Report to: Development Services Committee

SUBJECT: Heritage Permit Application
Shakiba Dilmaghani and Massood Mashadi
149 John Street, Thornhill
Driveway Entrance Gate

PREPARED BY: Regan Hutcheson, Manager, Heritage Planning

Figure 1 – Photograph of Gate

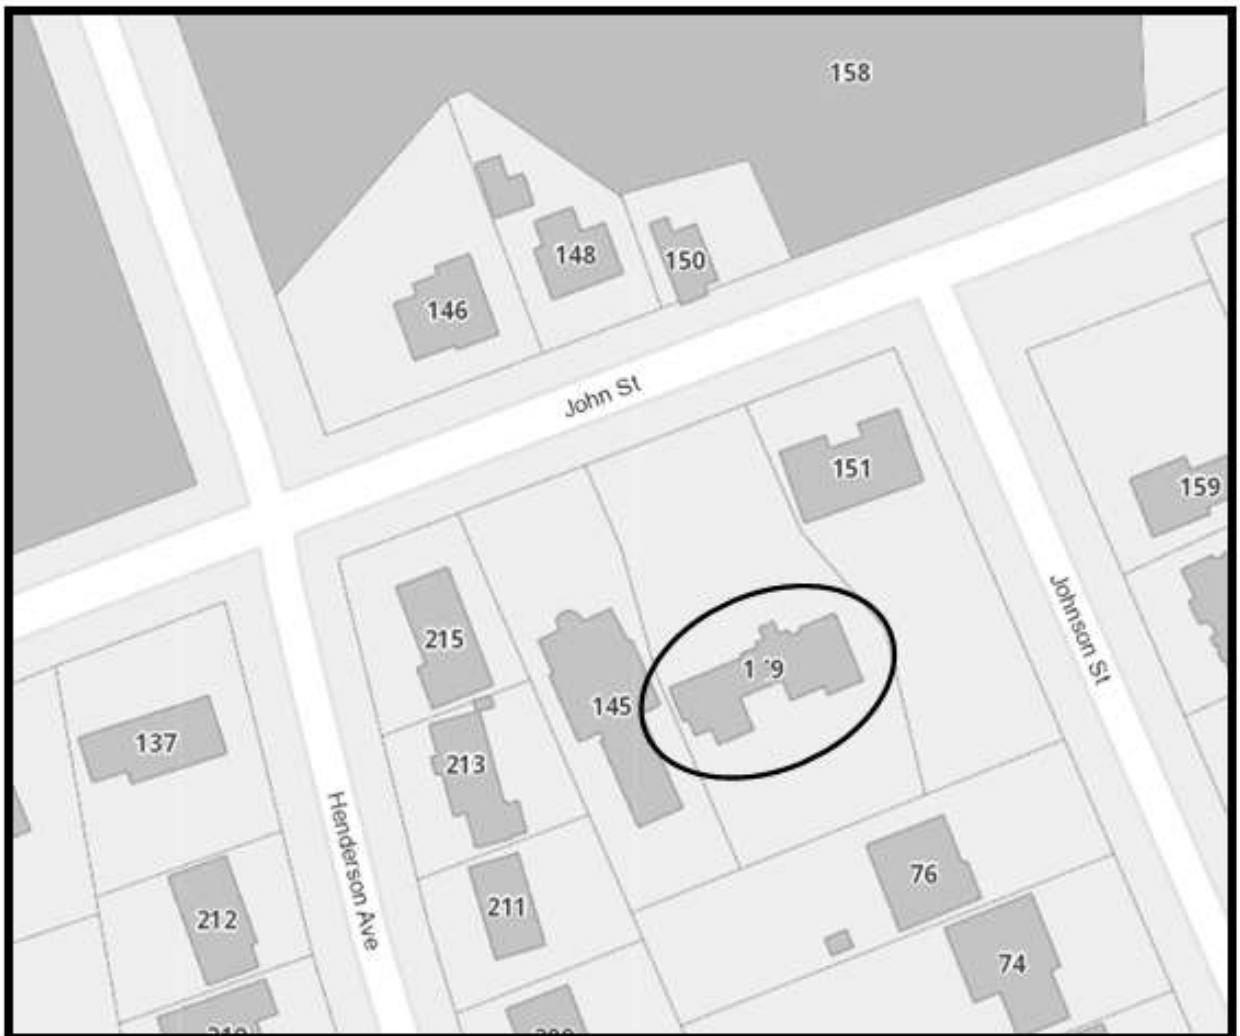
At the July 2015 meeting of Heritage Markham, staff was contacted by neighbours and made aware of a newly installed iron gate at 149 John St. which was not approved by the City. Staff visited the site and took photographs of the gate (see Figure 1). Staff noted that there were stone gate posts located at the end of the driveway which may have historically supported a gate, but staff has no photographic evidence of a former gate. By-law Enforcement was alerted in early August 2015, attended the property and advised the owners to remove the gate or seek approval from the City.

Given the policies of the Thornhill Heritage Conservation District Plan and the review and recommendation of this application by the Heritage Markham Committee, staff does not support the installation of the existing gate at 149 John Street.

That Heritage Markham does not support a heritage permit application to permit the existing gate installed without City approval at 149 John Street; and

That the owners of the property be advised that the iron gate installed at 149 John Street, without City approval be removed no later than 30 days.
